Subject: Issuance of Amendment (Licensing Action TAC #60581)

BEAVER VALLEY POWER STATION, UNIT NO. 1

AMENDMENT TO FACILITY OPERATING LICENSE

Amendment No. 110
License No. DPR-66

Figure 6.2-1
ACORPORATE ORGANIZATION (Partial)

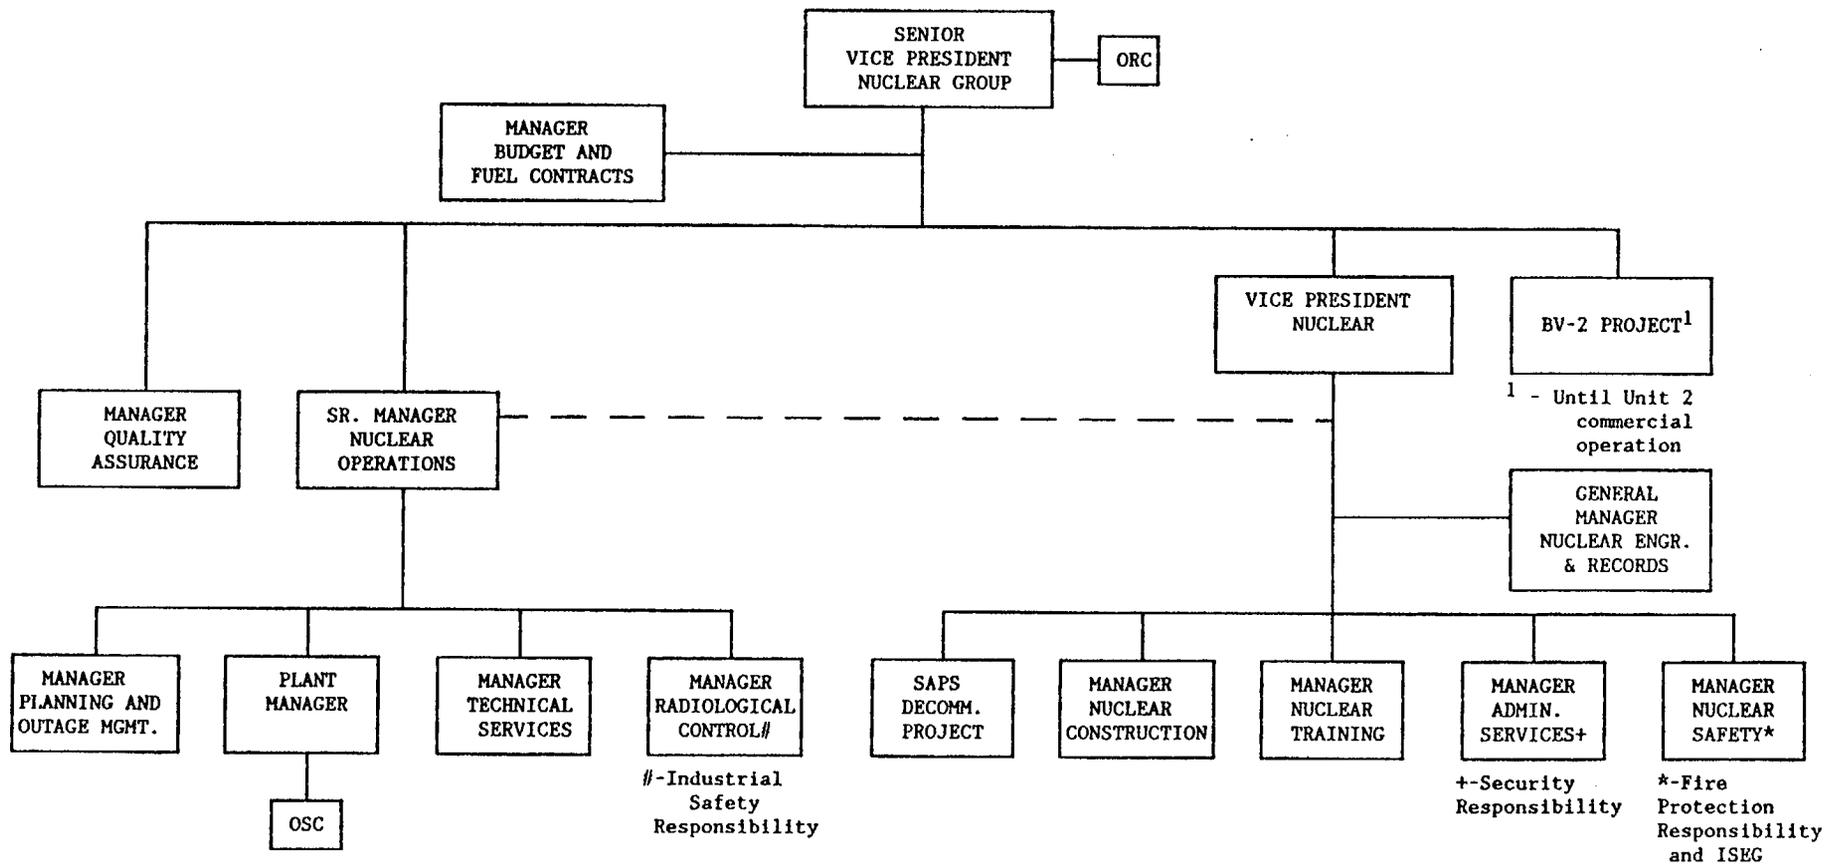
3. Figure 6.2-1 - The January 15, 1986 letter proposed extensive changes to this figure, including a title change to "Corporate Organization (Partial)", consistent with Item 2, above. The licensee's letter of May 8, 1986, provided a comparison of the new position titles with the titles appearing in the existing Technical Specifications, and a functional description of each of the new positions. Our review of the proposed changes indicated that the resulting organization would be in accordance with the guidance of the Standard Review Plan, Section 13.1.1.

The licensee's letter dated January 15, 1987 (Revision 2) proposed to further modify the corporate organization. The previously proposed title change of the senior nuclear officer to Nuclear Group Vice President would be further changed to Senior Vice President, Nuclear Group. This is a title change only and is acceptable. Reporting to this position would be a Manager, Budget and Fuel Contracts; a Manager, Quality Assurance; a Senior Manager, Nuclear Operations; a Vice President, Nuclear; and the Beaver Valley Unit 2 Project. The latter office will disband when Unit 2 achieves commercial operation.

The Senior Manager, Nuclear Operations is the proposed new title for the previously designated Nuclear Operations General Manager. Reporting to this position would be the Plant Manager; the Manager, Technical Services; the Manager, Planning and Outage Management; and the Manager, Radiological Control.

The newly established Vice President, Nuclear would provide support services to the nuclear program. Reporting to this position would be the Manager, Nuclear Training; the Manager, Nuclear Construction; the Manager, Admin. Services; the Manager, Nuclear Safety; the General Manager, Nuclear Engineering and Records; and the Shippingport Atomic Power Station (SAPS) Decommissioning Project.

The March 17, 1987 letter (Revision 4) further modified Figure 6.2-1 to show the Offsite Review Committee (ORC) reporting to the Senior Vice President, Nuclear Group, and the Independent Safety Engineering Group (ISEG) reporting to the Manager, Nuclear Safety, who reports to the Vice President Nuclear. These reporting relationships are consistent with the SRP Section 13.4 requirements and are acceptable.

that normally are provided at the corporate level and that the functional groupings for corporate support are logically organized. Overall, the proposed revisions result in an organization that is consistent with the guidance of the Standard Review Plan, Section 13.1.1. We therefore find the proposed organization acceptable.
